**Valentine Gold Project: Federal
Information Requirements**

Round Four Information Requirements:
Response to IR(4)-11

RESPONSE TO IR(4)-11

Figure IR(4)-11.1 Particle Traces Illustrating Flow Paths from Waste Rock Piles, LGO Stockpiles and TMF at End of Project Operation (Update of Figures 5-3 from Appendix 6A of the EIS)

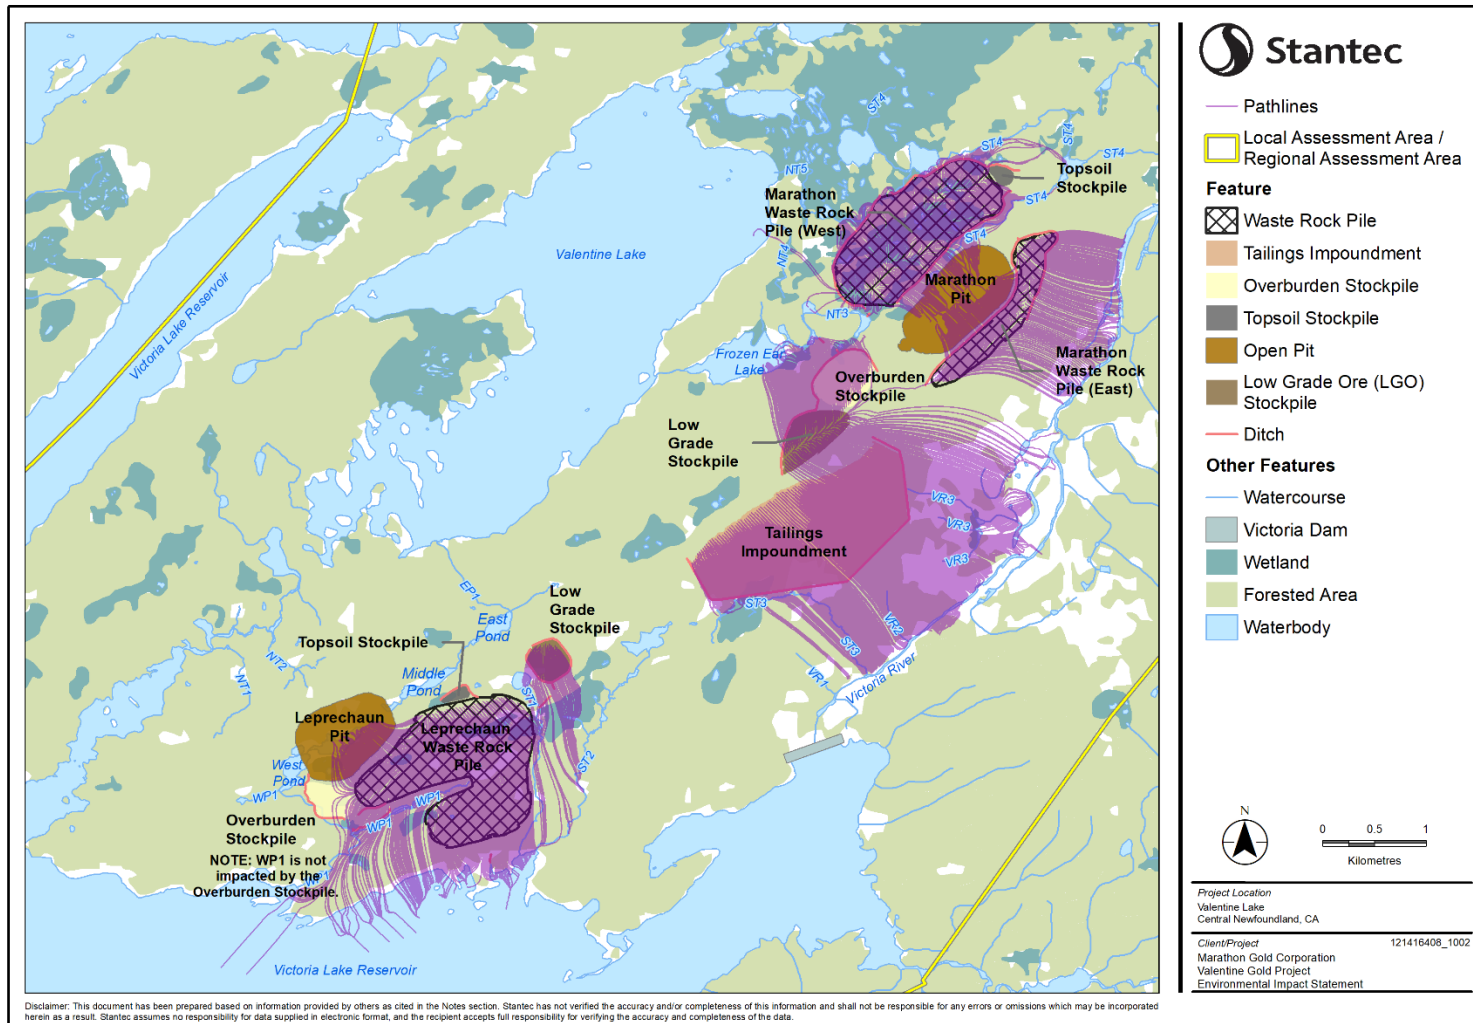
IR 4 Reference #:	IR(4)-11
	<p>that be the case, seepage quantity from these facilities is expected to be the same as those presented in the EIS, and would then comprise a larger portion of the total groundwater discharge to surface water, with potential implications for surface water and fish and fish habitat.</p> <p>To support the conclusions of the assessment, groundwater balances should be provided for the waste rock storage and TMF (i.e., a description of the recharge to the facilities, the simulated seepage quantity, and the seepage discharge locations (including the ditch network)). Maps showing particle tracking results should accompany the flow balances.</p> <p>Results should be presented for both operations and post-closure conditions.</p>
Information Requirement:	<p>For waterbodies represented using the MODFLOW RIVER boundary in the updated model, provide a complete groundwater flow balance as provided in response to IR(2)-11, Table IR(2)-11.1.</p> <p>For the end of operations and post- closure conditions provide groundwater balances for the waste rock and tailings management facilities that include:</p> <ol style="list-style-type: none"> a. Recharge into the facility b. Seepage quantity from the facility c. Seepage discharge locations (including the ditch network), and the proportion of the total seepage discharging at each location <p>Provide particle tracking results in plan view for the end of operations and post- closure conditions.</p> <p>To further clarify the items listed above, the Proponent should provide updated versions of the following from Appendix 6A of the EIS:</p> <ul style="list-style-type: none"> • Figures 5-3 and 5-5 (with TMF particle tracks, as provided for previous IR responses) • Tables 5-4 and 5-7 (with TMF seepage proportions)

IR 4 Reference #:	IR(4)-11
	<p>adverse effects to Groundwater Resources or ultimately to the Surface Water Resources or Fish and Fish Habitat VCs.</p> <p>The present model results using the revised groundwater model from Appendix IR(3)-11.1 with the refined Project footprint are not substantively different from those presented in Appendix IR(3)-11.1, and therefore, the refined Project footprint also does not change the conclusions presented in the EIS with respect to residual Project effects on Groundwater Resources, Surface Water Resources or Fish and Fish Habitat. This is consistent with the assessment and conclusions presented in the Project refinements letter submitted to IAAC on January 10, 2022 (refer to Section 2.2 of Attachment A).</p>
Appendix:	None
